**FOR PLANNING**  
 \$2 ISSUED FOR INFORMATION

PROJECT: **Cowabaki ICT Facility**  
 REGIONAL OFFICE:  
 PROJECT: **DUB 10 - BUILDING 2 ELEVATIONS - PROPOSED**  
 SCALE: **As Indicated B.A.2**  
 DRAWING NO: **D10-ARC-B2-Z7-DR-A-301**  
 REVISION:

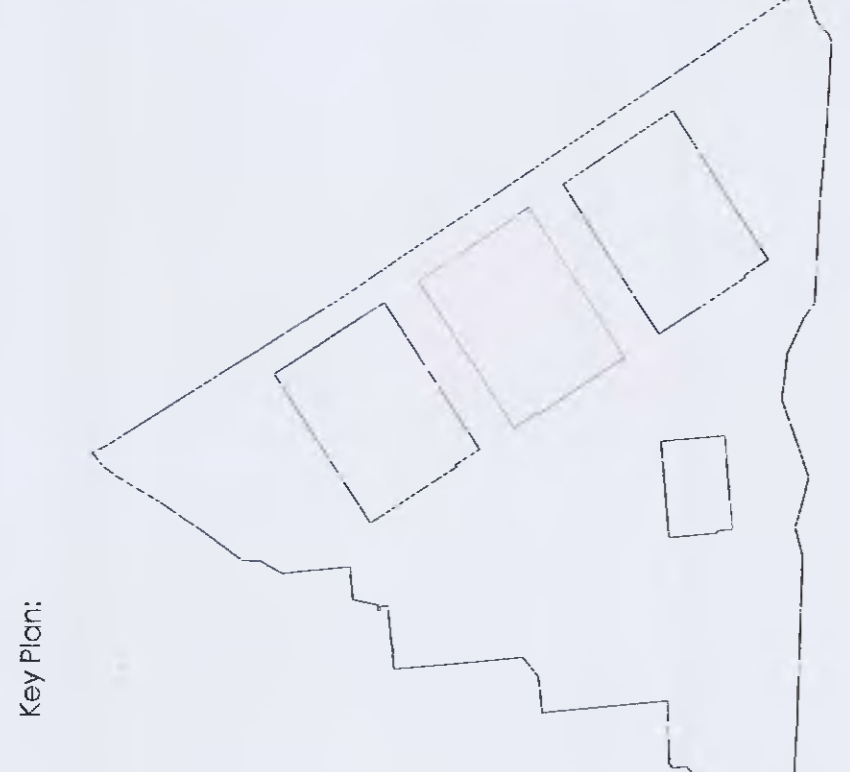
- REVISION KEY:**
1. CENTRAL EXHAUST DUCTS EXTENDING ABOVE PARAPET REMOVED.
  2. CENTRAL EXHAUST DUCTS EXTENDING ABOVE PARAPET REMOVED. HEIGHT INCREASED FROM 19.5M TO 20.7M.
  3. EAST ELEVATION GLAZING REMOVED DUE TO INTERNAL LAYOUT CHANGES.
  4. EAST ELEVATION GLAZING REMOVED DUE TO INTERNAL LAYOUT CHANGES.
  5. GLAZING ELEVATION UPDATES DUE TO INTERNAL LAYOUT CHANGES.
